Access Compliance Report

Public Rights-of-Way

(Curb Ramps)

Intersection ID: 45499	Main Street: BUGGY_HORSE_RD	Cross Street: GRASSY_CROPS_RD	Location: W
ADA ID: EC547D51C6F5	Ramp Type: PerpDiag	Initial Pass/Fail: Fail	Overall Compliance: No
Severity Score: 42.5			
Codes/Mitigation Info/Possible Solution		Field Measurements/Component Compliance

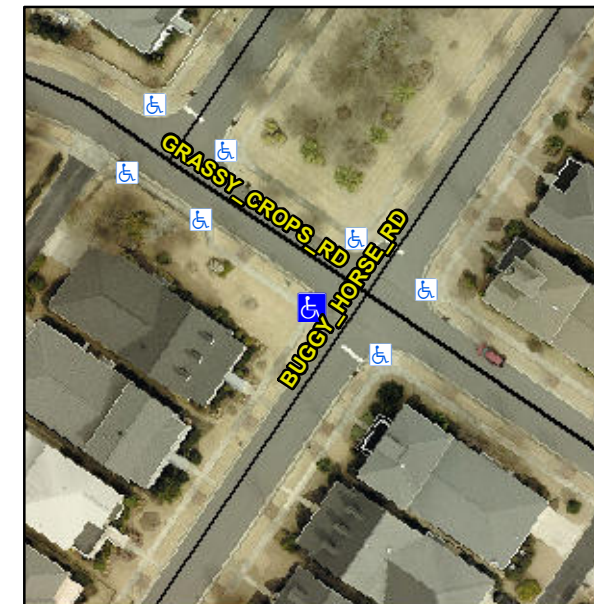
Remove & Replace Curb Ramp With Two New Directional Ramps or Equivalent.

Not Found, R304.5.1, R304.2.2

Compliance	Description	Data	Compliance	Description	Data
N/A	Ramp Length (in)	71.0	No	Ramp Slope (%)	13.3
No	Ramp Width (in)	35.0	Yes	Ramp XSlope (%)	0.7
N/A	Flare Type LT	N/A	N/A	Flare Type RT	N/A
N/A	Flare Slope LT (%)	N/A	N/A	Flare Slope RT (%)	N/A
N/A	Flare Traversable LT?	N/A	N/A	Flare Traversable RT?	N/A
N/A	Landing Length (in)	N/A	N/A	DWS Provided?	N/A
N/A	Landing Width (in)	N/A	N/A	DWS Contrast?	N/A
N/A	Landing Slope (%)	N/A	N/A	DWS Length (in)	N/A
N/A	Landing X Slope (%)	N/A	N/A	DWS Full Width?	N/A
N/A	Landing Curb? (Y/N)	N/A	N/A	DWS Offset (in)	N/A
N/A	Shared Landing?	N/A			
N/A	Gutter Ponding?	N/A	N/A	Gutter Slope (%)	N/A
N/A	Gutter Lip Ht (in)	N/A	N/A	Gutter X Slope (%)	N/A
N/A	Painted X Walk1?	No	N/A	Painted X Walk2?	No
	X Walk 1 Direction	To SE		X Walk 2 Direction	To NE
N/A	X Walk 1 Width (in)	N/A	N/A	X Walk 2 Width (in)	N/A
	X Walk 1 Slope (%)	0.8		X Walk 2 Slope (%)	2.6
	X Walk 1 X Slope (%)	0.2		X Walk 2 X Slope (%)	0.7
